Proposed Hydro-electric Generating Station at the Bala Falls
Too dangerous to be in the middle of a popular in-water recreational area
Would not comply with 2013 Environmental Approval

The proponent's plan is too dangerous

Proposed generating station would make the water dangerous outside of their proposed downstream safety boom

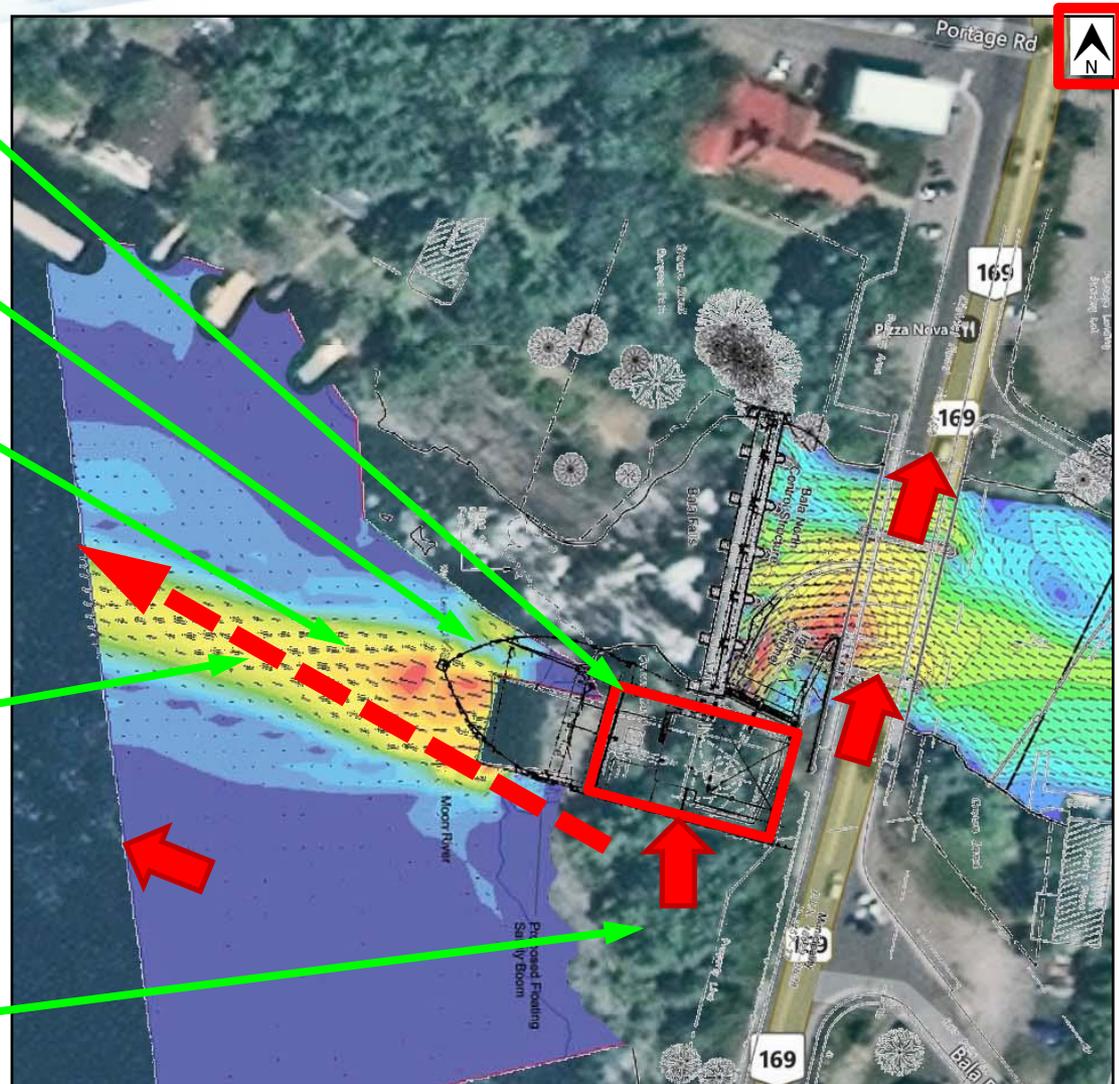
Proposed downstream safety boom

Proponent's flow simulation

Canoe path to and from proposed portage

Proposed generating station would make the water dangerous outside of their proposed downstream safety boom

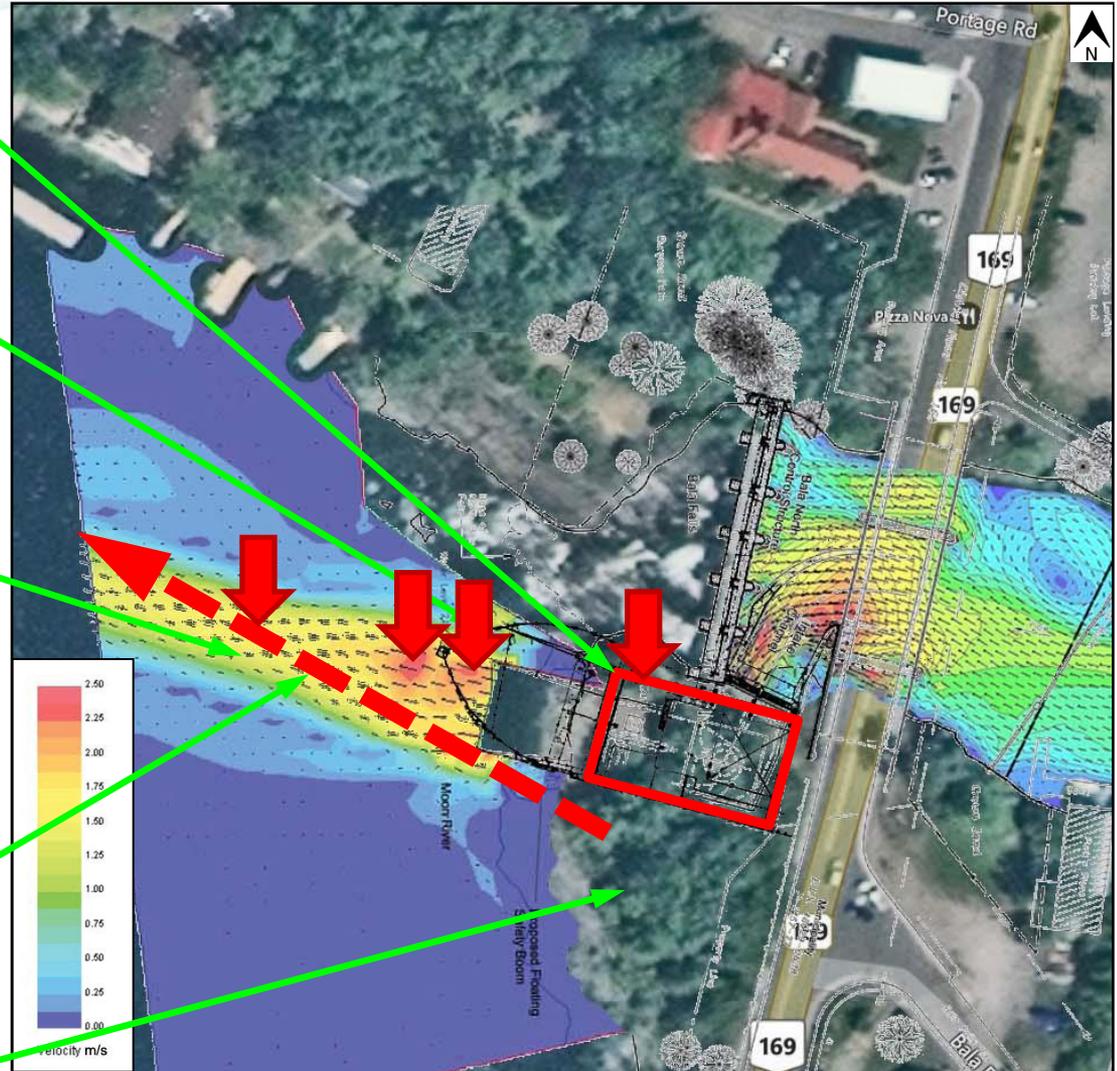
Proposed hydro-electric generating station would start without warning

Proponent's flow simulation shows water outside of proposed safety boom would be at least double the speed considers safe

Proponent's proposed portage would encourage canoeing and kayaking through dangerous water outside of safety boom

Required to be farther upstream

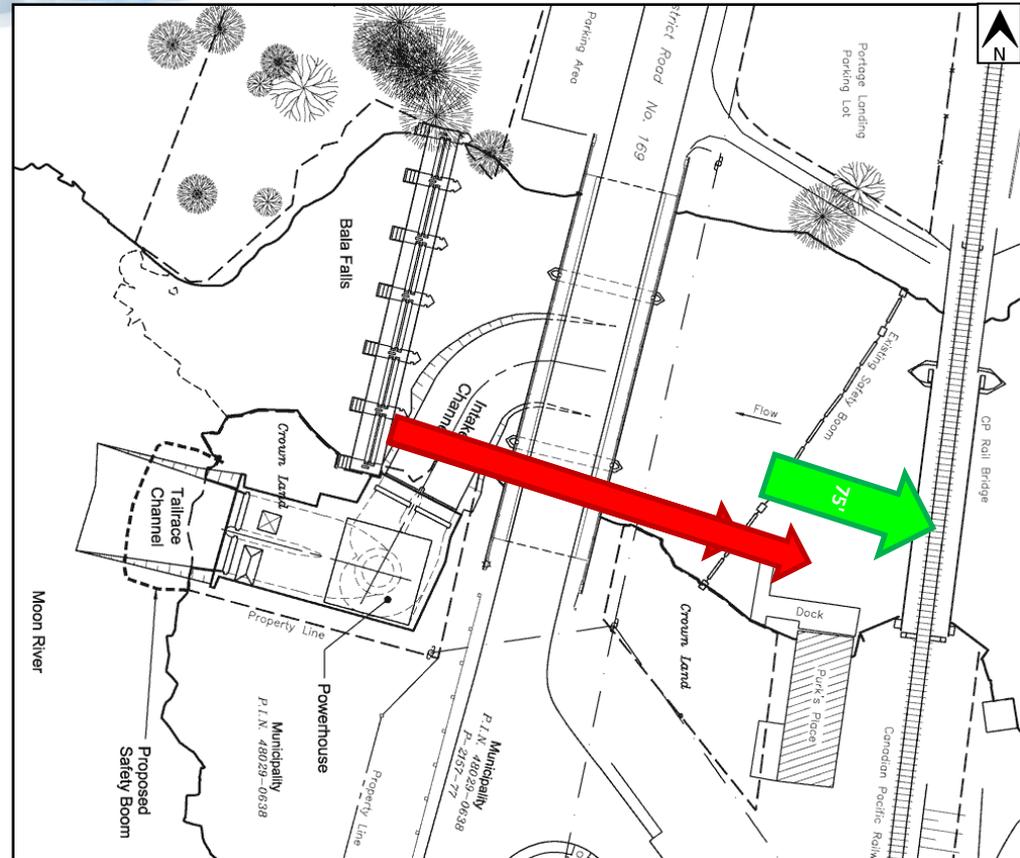
GREATEST DISTANCE = 90 m per Method 2
DISTANCE VARIES FROM 25-50m
FROM CURRENTLY ABOUT 5m FROM DAM

- Transport Canada's methods require the upstream safety boom to be **farther upstream due to the intake** for proposed generating
 - By 10 m due to remote operation
 - Plus 13 m width of intake

- Result would be boats could not reach Purk's Place docks
 - Riparian rights are protected by law, so infringement is not allowed

Proposed upstream cofferdam

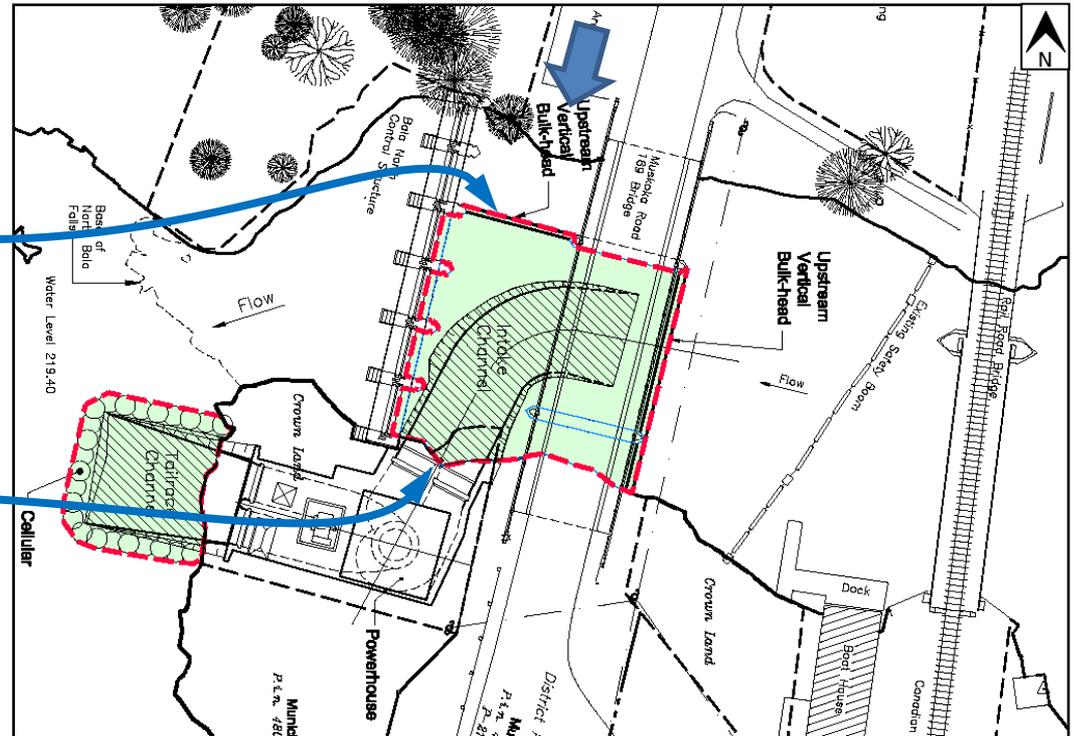
(Risks damaging both MNRF's Bala north dam and District's highway bridge, flooding the Moon River and requiring a 50 km detour)

- During the proposed construction, an upstream cofferdam would be needed to keep water from the intake excavation

- The proponent's schemes which received Environmental Approval did not threaten damage to other's crucial infrastructure

Anchoring the steel beams

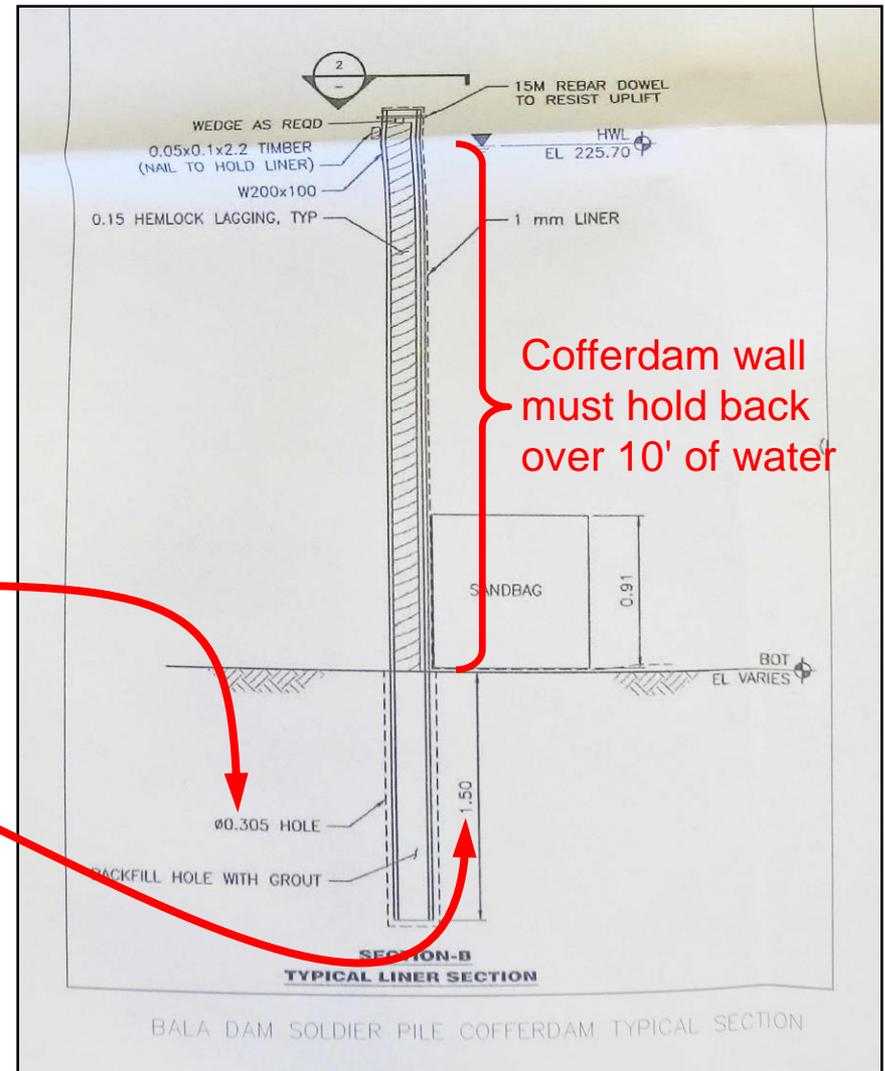
- The steel beams would be anchored by boring into the bed of the Bala north channel
 - Proponent's drawing shows a vertical beam every 8', each in a hole bored 1' in diameter and 5' deep
 - Boreholes would be **directly adjacent to dam and bridge piers**, and to intake excavation

Upstream cofferdam proposal

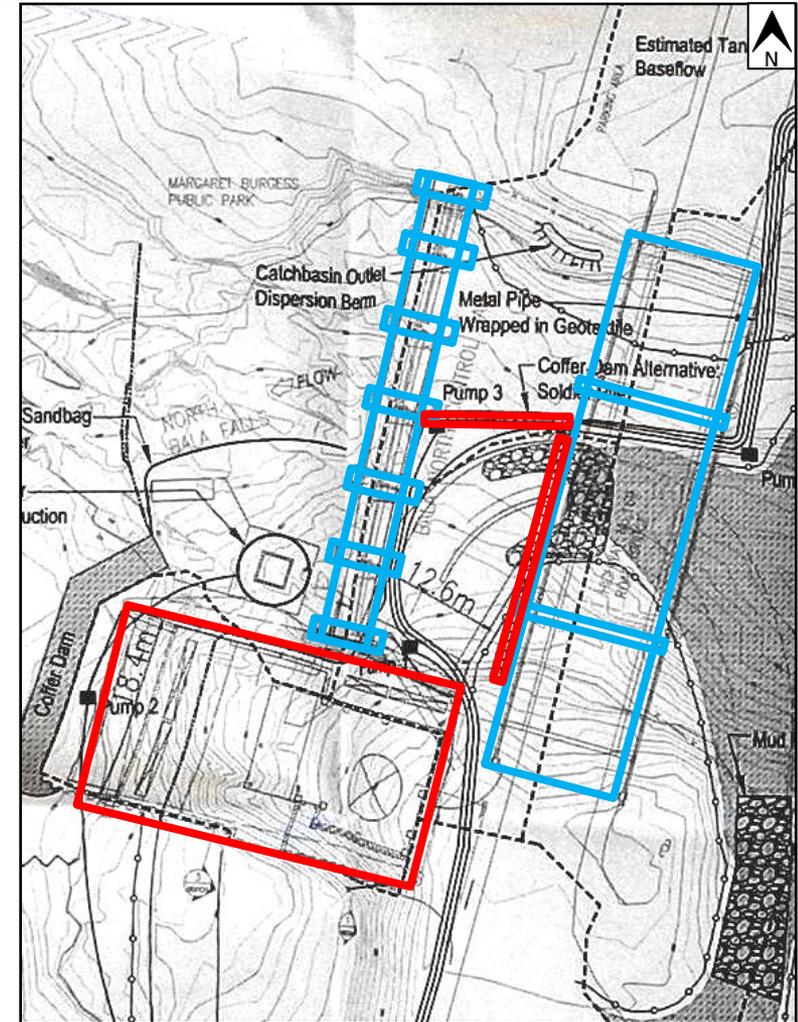
- Proponent's new upstream cofferdam proposal risks damage to both the MNRF's Bala north dam and the District's bridge
 - Their previous cofferdam proposal would not comply with the MNRF's cofferdam lowering plan
 - Damage to the dam could result in **flooding the Moon River**
 - Damage to the bridge could result in a **50 km detour** for months
- These risks have not been conveyed to all stakeholders

But wait, it gets worse

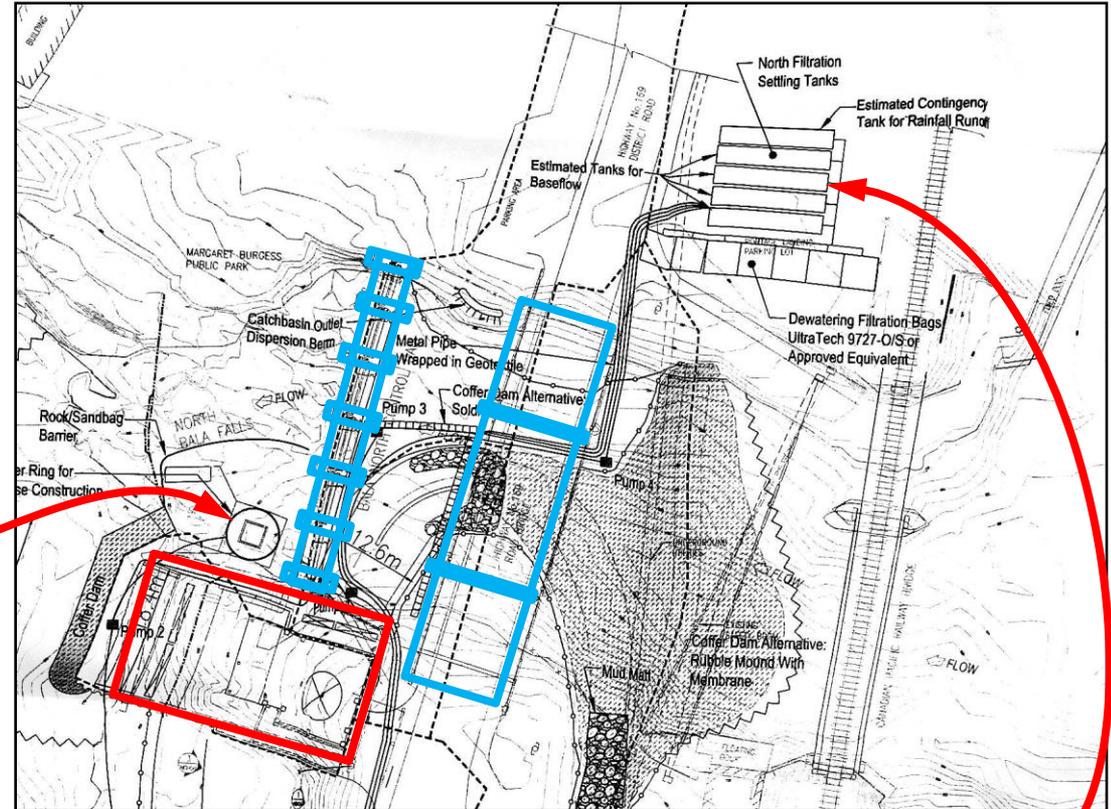
- This larger view of the proponent's October 20, 2016 drawing shows other concerns
 - Mount for proposed construction crane would obstruct flow through sluice 6, which MNRF would not allow
 - Settling tanks in the Don's Bakery parking lot are not allowed by the proponent's lease from the Township of Muskoka Lakes
- Proponent is providing conflicting information to stakeholders
